SUBJECT : Hyundai ImageQuest Co., Ltd.
FCC ID: PJIL17A00000
Class II Permissive Change
Orig. Grant Date : March 29, 2005

Transmitted herewith, on behalf of Hyundai ImageQuest Co., Ltd. is an application for a Class II Permissive Change Certification of the following 17-inch LCD Monitor:

FCC ID : PJIL17A00000
Type No. : L17A00000

• Solution for EMI

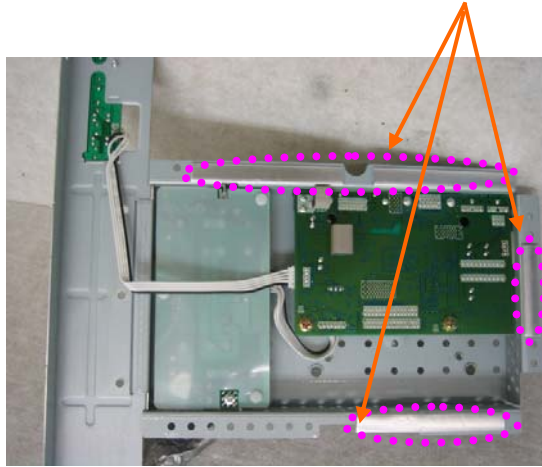
1. Attach a gasket on the main frame to contact the lcd panel

2. Attach a gasket on the main board to contact the main frame

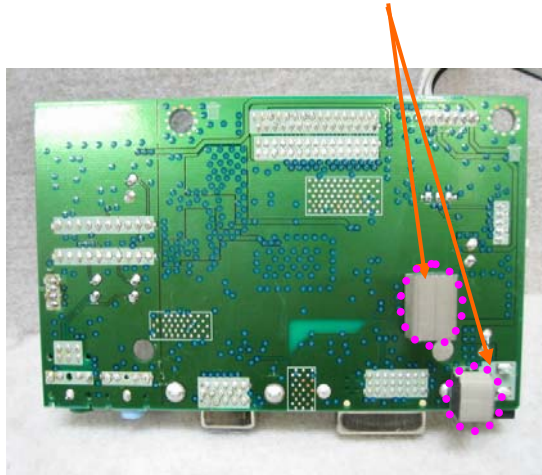
3. Attach aluminum tape on the Rear frame.
